Groundwater Application Review Summary Form

Application # G- 18910

GW Reviewer Karl Wozniak Date Review Completed: 2-19-2020

TO: Water Rights Section Date February 19, 2020
 FROM: Groundwater Section Karl Wozniak
 Reviewer's Name
 SUBJECT: Application G- 18910 Supersedes review of
 Date of Review(s)

Well Statistics (Sections 2 & 3, 13S/1W)

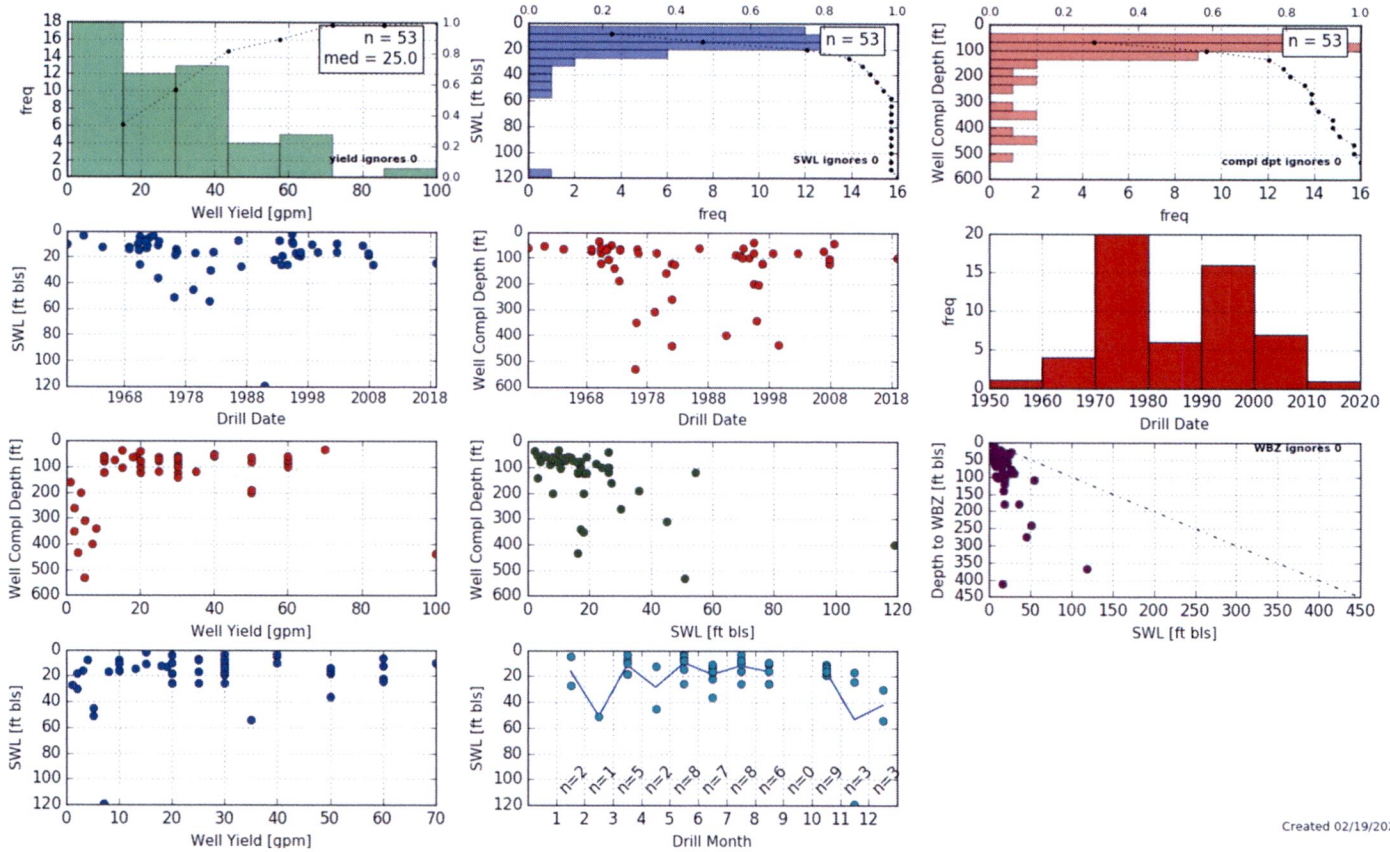
No observation wells are available in the surrounding area but local well reports show no obvious trend in static water levels over time (see attached plot). This fact and the relatively low density of wells in the area indicate that groundwater levels are probably stable at the present time.

Well Location Map

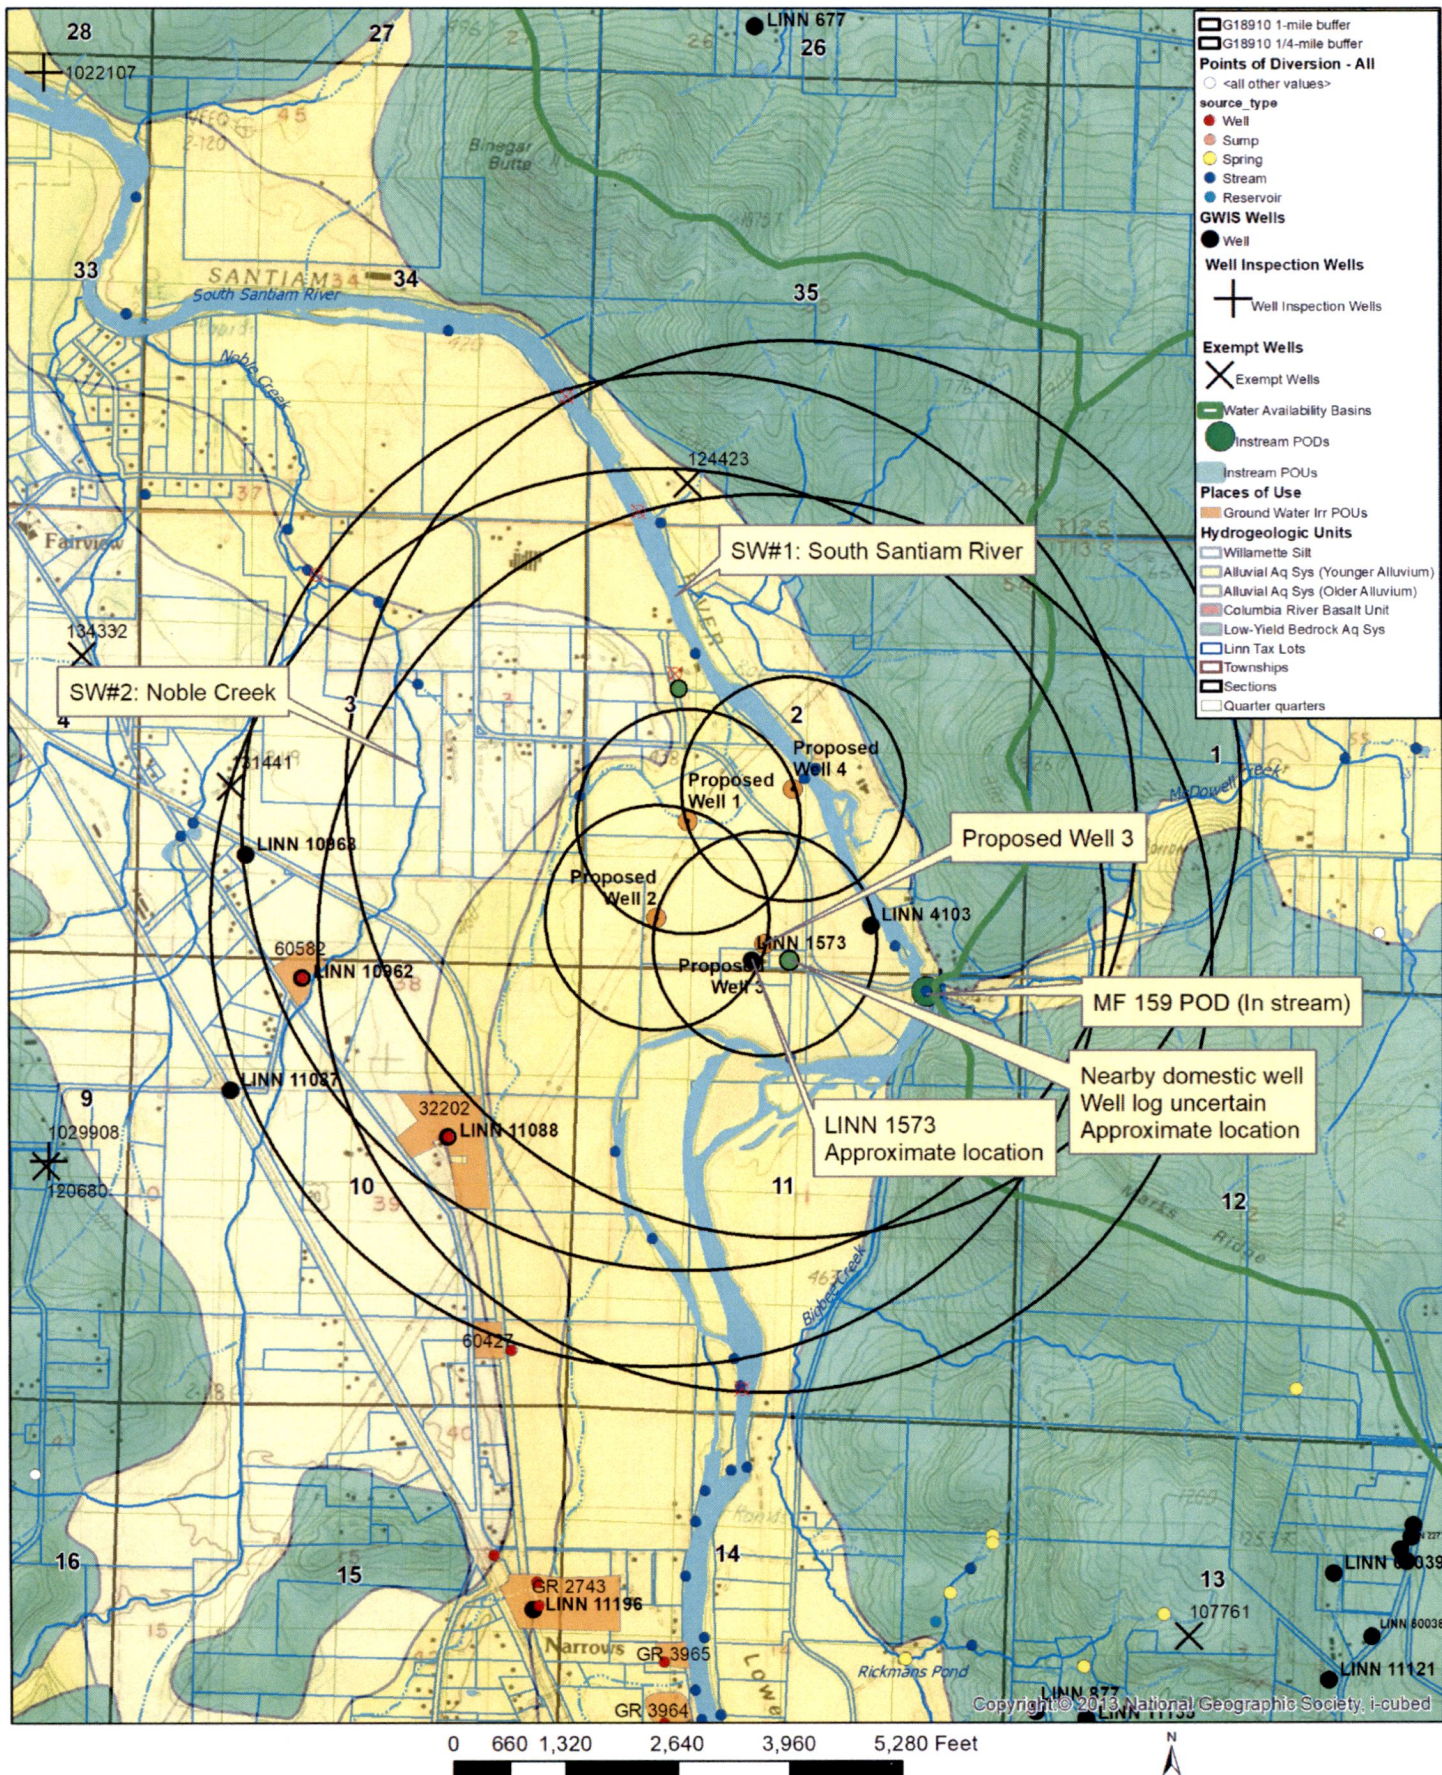
The application map incorrectly states that Proposed Well 1 is 750 feet east and 540 feet north of the northeast corner of DLC 38 but the plotted location is actually 750 feet north and 540 feet east of the said corner. This review assumes that the plotted location is correct and shows the corrected location in table A3 and on the enclosed map.
